Access Compliance Report

Public Rights-of-Way

(Curb Ramps)

Intersection ID: 2593	Main Street: BEARDSLEY_DR	Cross Street: DURSTON_CT	Location: SW
ADA ID: 815D8DAF6ABA	Ramp Type: BlendTrans1	Initial Pass/Fail: Fail	Overall Compliance: No
			Severity Score: 21.25

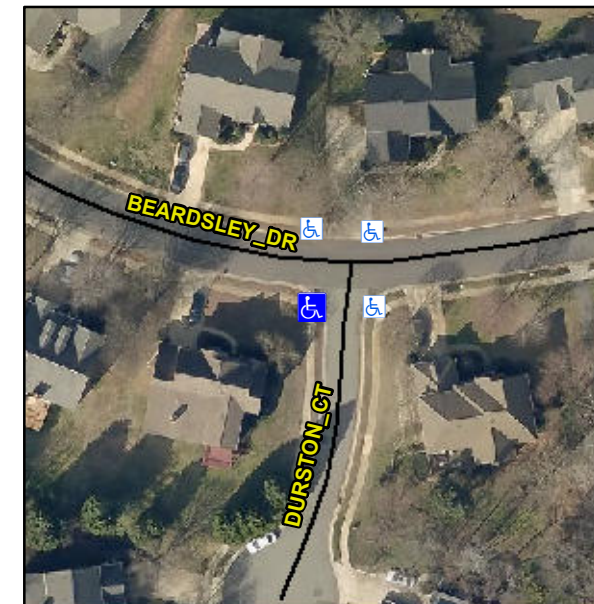
R304.5.1, R304.5.3

Compliance	Description	Data	Compliance	Description	Data
N/A	Ramp Length (in)	46.0	Yes	BlendTrans Slope (%)	1.0
No	Ramp Width (in)	46.0	No	BlendTrans XSlope (%)	5.1
N/A	Flare Type LT	N/A	N/A	Flare Type RT	N/A
N/A	Flare Slope LT (%)	N/A	N/A	Flare Slope RT (%)	N/A
N/A	Flare Traversable LT?	N/A	N/A	Flare Traversable RT?	N/A
N/A	Landing Length (in)	N/A	N/A	DWS Provided?	N/A
N/A	Landing Width (in)	N/A	N/A	DWS Contrast?	N/A
N/A	Landing Slope (%)	N/A	N/A	DWS Length (in)	N/A
N/A	Landing X Slope (%)	N/A	N/A	DWS Full Width?	N/A
N/A	Landing Curb? (Y/N)	N/A	N/A	DWS Offset (in)	N/A
N/A	Shared Landing?	N/A			
N/A	Gutter Ponding?	N/A	N/A	Gutter Slope (%)	N/A
N/A	Gutter Lip Ht (in)	N/A	N/A	Gutter X Slope (%)	N/A
N/A	Painted X Walk1?	No	N/A	Painted X Walk2?	No
	X Walk 1 Direction	To E		X Walk 2 Direction	To N
	X Walk 1 Width (in)	N/A		X Walk 2 Width (in)	N/A
	X Walk 1 Slope (%)	3.1		X Walk 2 Slope (%)	4.3
	X Walk 1 X Slope (%)	5.8		X Walk 2 X Slope (%)	0.2

Remove & Replace Curb Ramp With Two New Directional Ramps or Equivalent.
